Item Name: 205 Skidtube bent detail

D2580-041 ASSEMBLY DETAIL

DRAWING NO. D2580	TITLE 205 SKIDTUBE ASSEMBLY	REV. E	DART AEROSPACE LTD ENGINEERING ORDER	D.E.O. NO. D2580-E-1	SHEET NO. SHEET 1 OF 1	SCALE NTS
DRAWN UP	CHECKED ASS	MFG. APPR. EC	APPROVED H	DE APPR. H		
DATE 11.12.13	DATE 11.12.13	DATE 11.12.13	DATE 11.12.13	DATE 11.12.13	DATE 11.12.13

CHANGE ALL C'BORED WELDED CROSSBOLT SPACERS TO SWAGED SPACERS

SECTION F-F D5-5
SCALE 5X

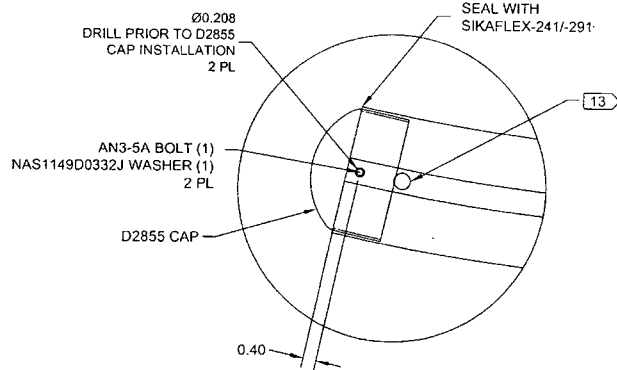
WELD 4X D2579 SPACERS PER DWG
IN LOCATIONS MARKED "NO C'BORE".
REF SHEET 4 OF DWG.

SECTION B-B, F-F, I-I
NOT TO SCALE

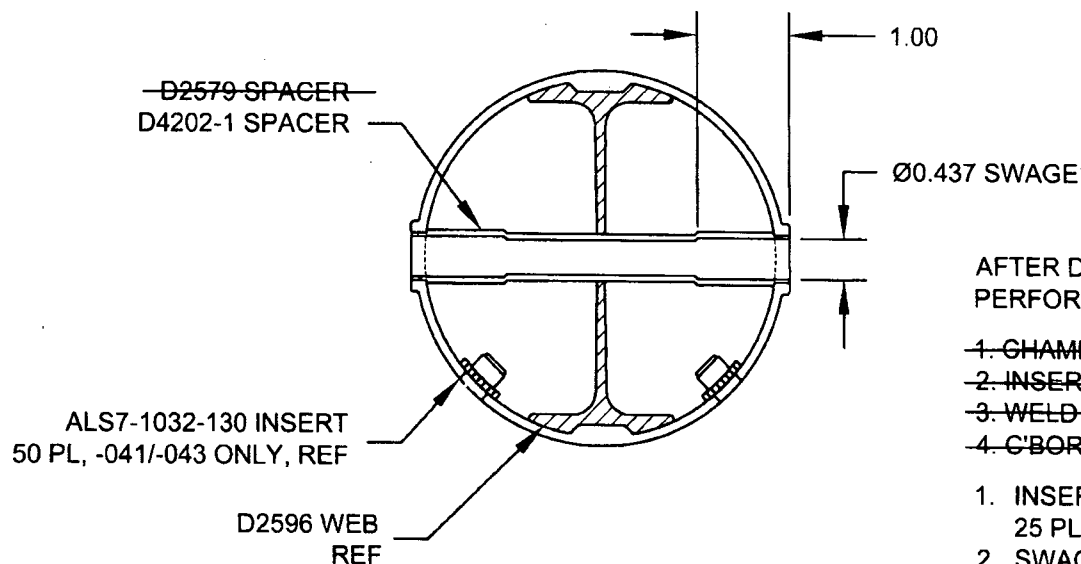
SECTION B-B, SECTION F-F, & SECTION I-I ARE AMENDED AS FOLLOWS
FOR ALL HOLES THAT WERE ORIGINALLY C'BORED:

- ~~1. CHAMFER HOLE 0.050 X 45°~~
- ~~2. INSERT D2579 SPACER (20 PLACES)~~
- ~~3. WELD INTO PLACE AND GRIND FLUSH~~
- ~~4. C'BORE D2579 SPACER TO Ø0.437 X 1.00 DEEP~~

1. INSERT D4202-1 SPACER, 20 PL (-041) OR 20 PL (-045) OR 25 PL (-047)
2. SWAGE TO Ø0.437 X 1.00 DEEP PER QSI 002
3. TRIM / GRIND FLUSH PER QSI 002
